From: comms@dubbo.nsw.gov.au
Sent: Wednesday, 14 December 2022 4:28 PM
To: Dubbo Regional Council
Subject: DRAFT MACQUARIE RIVER MASTERPLAN

MACQUARIE RIVER MASTERPLAN NORTH AND SOUTH PRECINCTS – SUBMISSION FORM

Proposed solutions

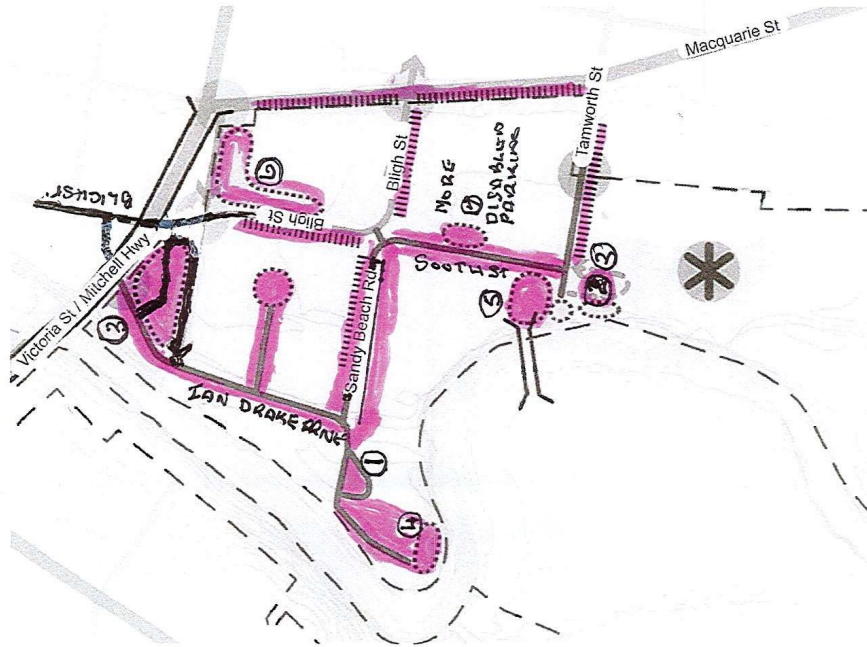
- 95/ NEEDS PARKING LINES
 - 96/ NEEDS PARKING LINES
 - 97/ NEEDS PARKING LINES
 - 98/ NEEDS PARKING LINES
 - 99/ NEEDS PARKING LINES
 - 100/ NEEDS PARKING LINES

- Connect internal streets
- Change some streets
- Provide additional on-street and off-street parking areas
 - ① UPGRADE CAR PARK.
 - ② UPGRADE CAR PARK.
 - ③ UPGRADE CAR PARK.
 - ④ UPGRADE CAR PARK.
 - ⑤ UPGRADE CAR PARK.

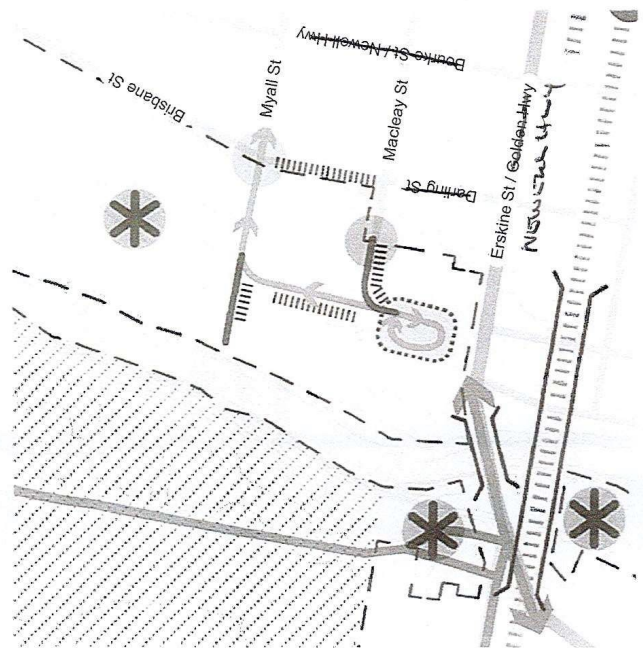
2. PROPOSED NEW NET BALL COURT
 COULD BE BUILT IN THE SOUTH EAST CORNER OF THE SITE
 ON RIVER SIDE LEAVING SITE ON RIVER SIDE LEAVING SITE ON RIVER SIDE
 MOVE DOWN MAIN ST TO BE OPEN AND MOVE FURTHER INTERCTIONS
 BLOCK TO TOUCH CLUB HOUSE EXTENDED NEW PARKING MOUNT
 SIDE (CENTRAL AREA A NO. 1) ETC.

1. EXTEND CARPARK SOUTH EAST END TO NEWELL HWY
 2. DIVERT STORM WATER DRAIN BY MYALL ST TO MAIN GUTTER
 3. PROVIDE PARKING FROM MAIN GUTTER TO RIVER BANK IN DOWN HILL INTERSECTIONS OVER TOUCH CLUB HOUSE
 4. TWO WAY ROAD INTO ONLY TOUCH CLUB HOUSE
 5. EXISTING CURVE AT TRAMWAY TO BE GRADED NORTH TO NORTH TO MYALL ST.
 6. BIG PARKING LOT ON NORTH SIDE OF MAIN MYALL ST.
